OHIO DEPARTMENT OF TRANSPORTATION
CENTRAL OFFICE, 1980 W. BROAD ST., COLUMBUS, OHIO 43216-0899

Re: 2014 Third Quarter Revisions

Summary of Revisions to the January 2004 ODOT BDM

Figure 210

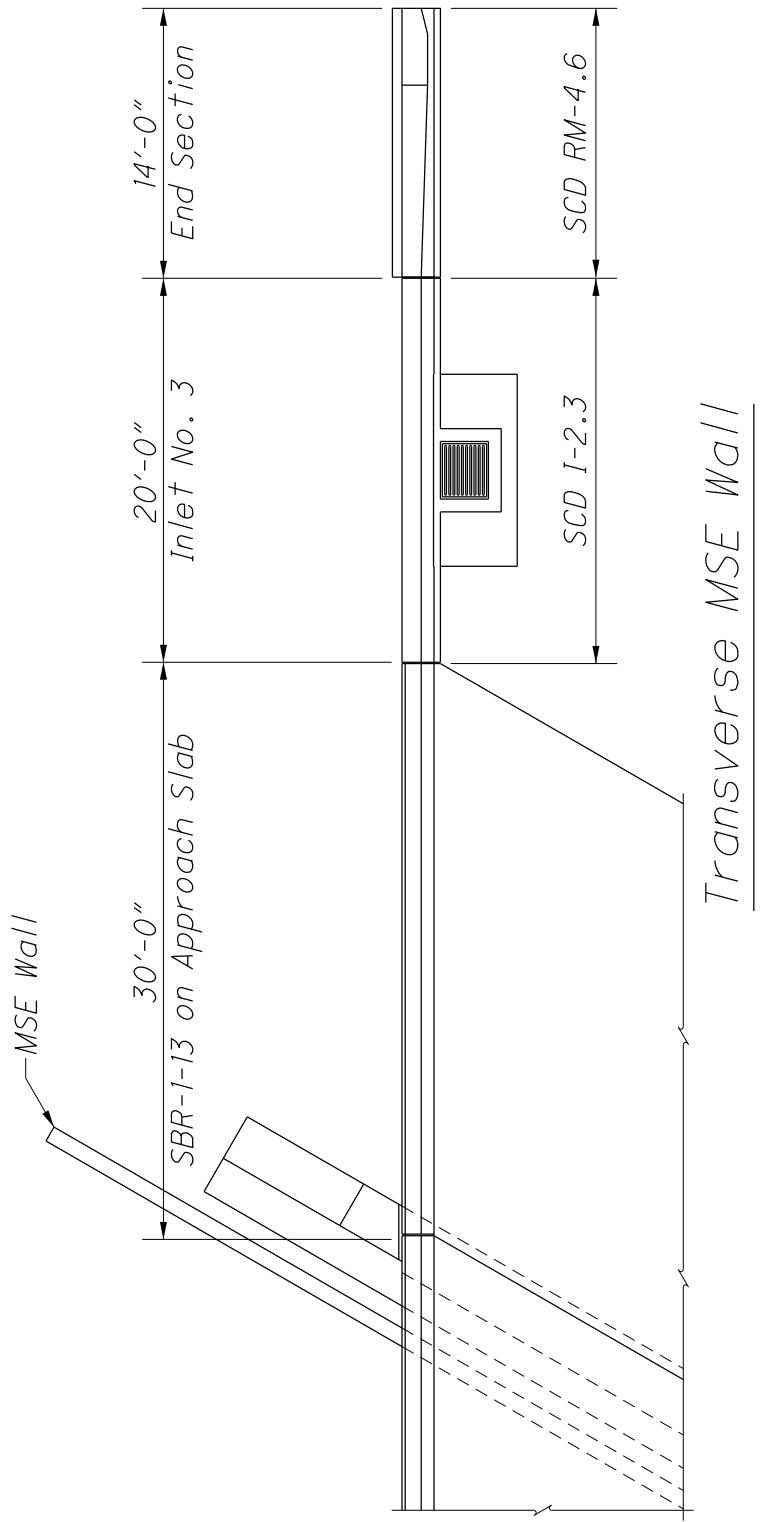
Control of drainage is especially critical at abutments with MSE walls. On structures with MSE walls at the abutments, a barrier shall be provided on the approach slab with a standard catch basin to collect the drainage. Where possible, the catch basin shall be located at least 25 ft beyond the limits of the MSE wall soil reinforcement. Continue the barrier 10 ft past the catch basin. Refer to BDM Figure 210 for more information.
